ENGINEERING CHANGE PROPOSAL (SHORT FORM)
(SEE MIL-STD-481 FOR INSTRUCTIONS)

8. TITLE OF CHANGE
Window Assembly

10. CONFIGURATION ITEM NOMENCLATURE
Switchboard, Telephone Manual SB-22A/PT

NOTICE OF REVISION (NOR)
(SEE MIL-STD-480 FOR INSTRUCTIONS)

TOLERANCES (EXCEPT AS NOTED)	REVISIONS						
	NO.	DATE	BY	2	1	6210-160	RING
				1	1	6210-101	NUT
				FIND NO.	QTY	PART NO.	DESCRIPTION
DECIMAL ± —	1			NUT & RING ASSY			
FRACTIONAL ± —	2						
	3			DRAWN BY JLH	SCALE 2/1	MATERIAL —	
ANGULAR	4			CHK'D	DATE 9-25-85	DRAWING NO. [illegible]

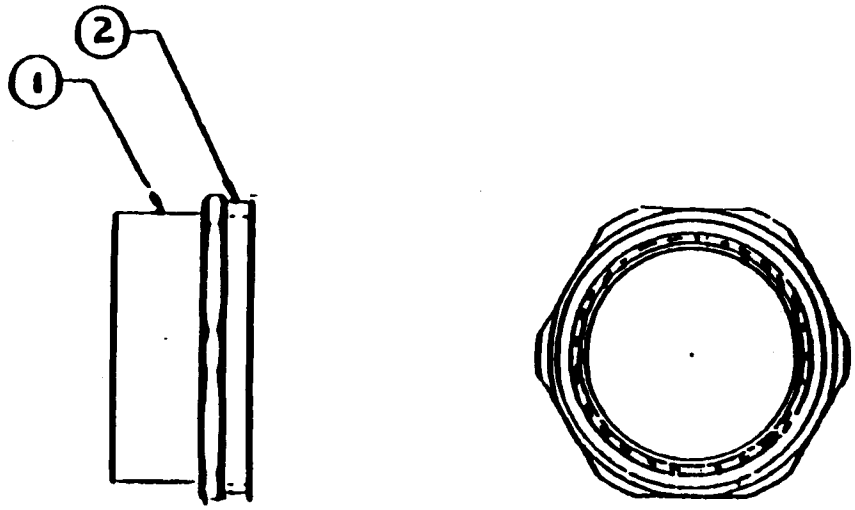
2. TITLE OF DOCUMENT	3. MFR. CODE	4. DOCUMENT NUMBER	5. REVISION LETTER	6. ECP NO.
Nut and Ring Assembly	80063	New	-	E5G0300001

In accordance with Sketch 6210-102 dtd 9/25/85 attached, on new Government drawing format.

STAKE OR ROLL OVER BOTTOM FLANGE OF FIND NO. 1 TO SECURE FIND NO. 2 TO FIND NO. 1.

TOLERANCES	REVISIONS			
UNLESS OTHERWISE NOTED	NO.	DATE	BY	
DECIMAL ± —	1			RING
	2			
FRACTIONAL ± —	3			DRAWN BY JLH · SCALE 2/1 · MATERIAL SEE NOTE 1
	4			CHK'D · DATE 9-14-85 · DRAWING NO
ANGULAR ± —	5			TRACED · APP'D · 6210-100

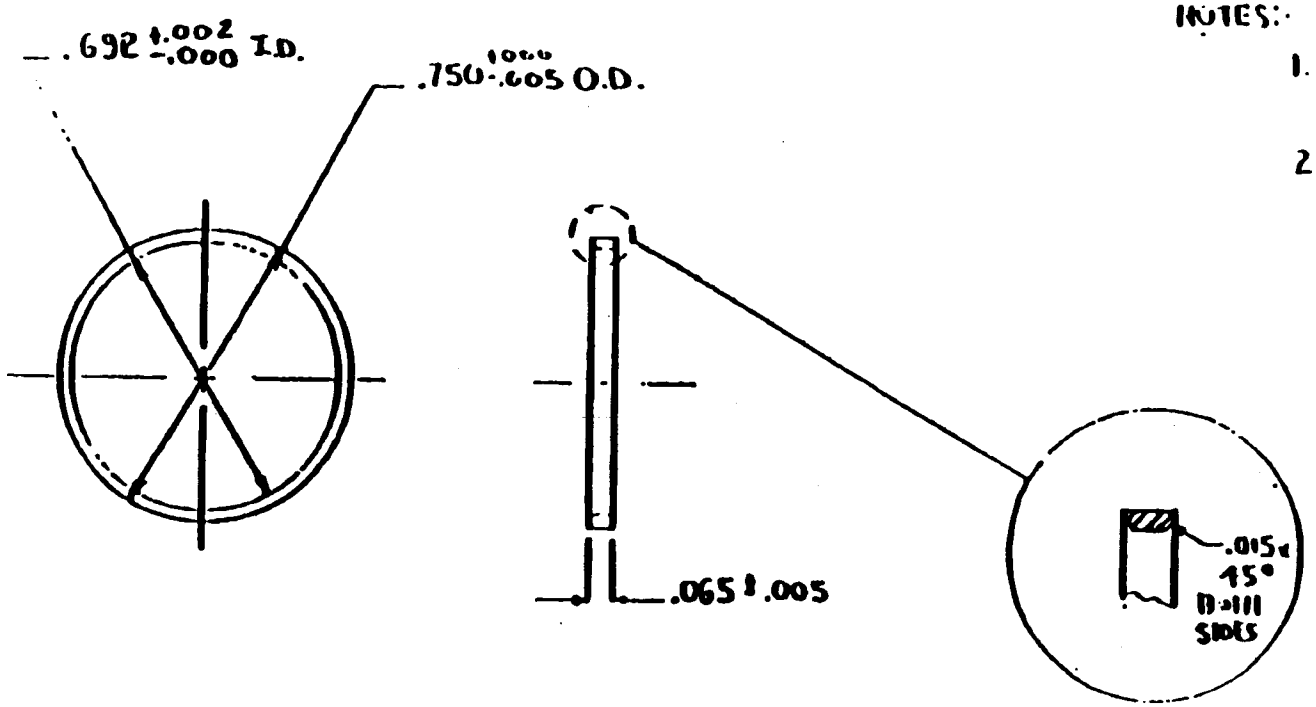
2. TITLE OF DOCUMENT	3. MFR. CODE	4. DOCUMENT NUMBER
Ring	80063	New
	5. REVISION LETTER (COMMENTS) -	6. ECP NO. ESG030000[illegible]

In accordance with Sketch # 6210-100 dtd 9/25/85 attached, on Government drawing format.

1. MAT'L: STEEL, FREE MACHINING, COLD FINISHED PER QQ-S-633
2. FINISH: M225 IAW MIL-F-14072

TOLERANCES (UNLESS OTHERWISE NOTED)	REVISIONS					
	NO.	DATE	BY	NUT		
DECIMAL .XX ± .010 .XXX ± .005	1					
FRACTIONAL ± 1/64	2					
	3			DRAWN BY JLH	SCALE 2/1	MATERIAL SEE NOTE 1
ANGULAR	4			CHK'D	DATE 9-25-85	DRAWING NO. 6210-101

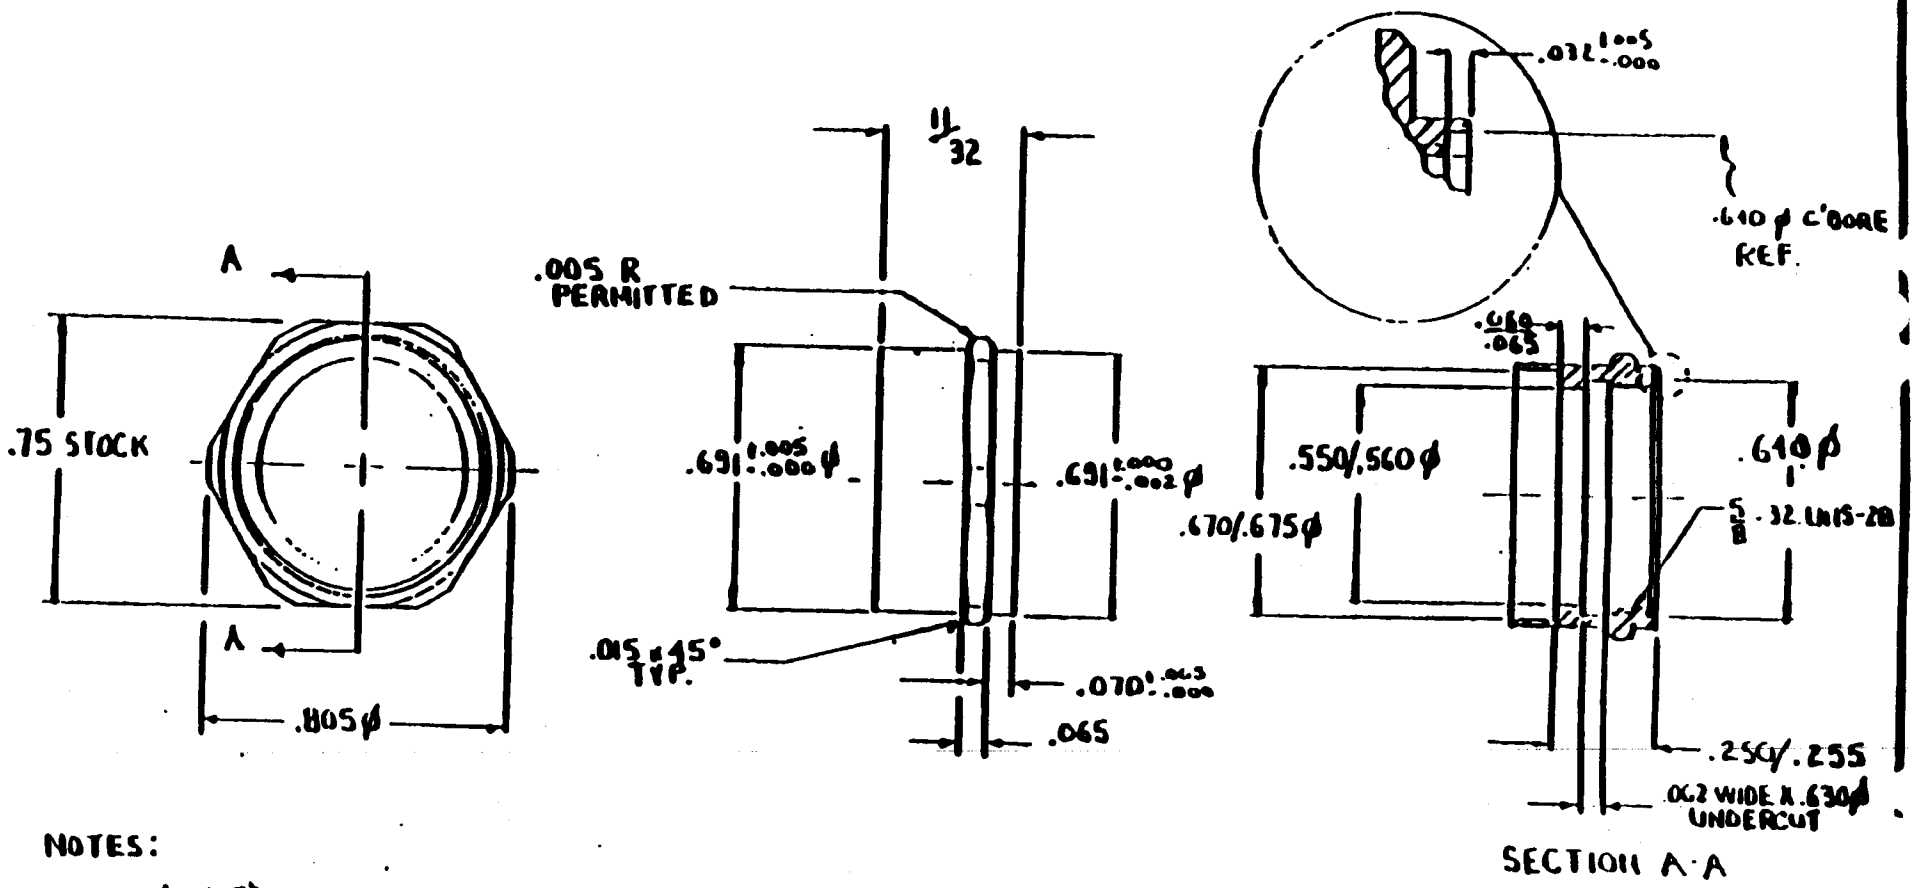
2. TITLE OF DOCUMENT	3. REQ. CODE	4. DOCUMENT NUMBER
Nut	80063	New
	5. REVISION LETTER (DOCUMENT) -	6. ACP NO. FSC03000

In accordance with Sketch # 6210-101 dtd 9/25/85 attached, on new Government drawing format.

1. MATL: BRASS, FREE MACHINING
2. FINISH M313 IAW MIL-F-14072
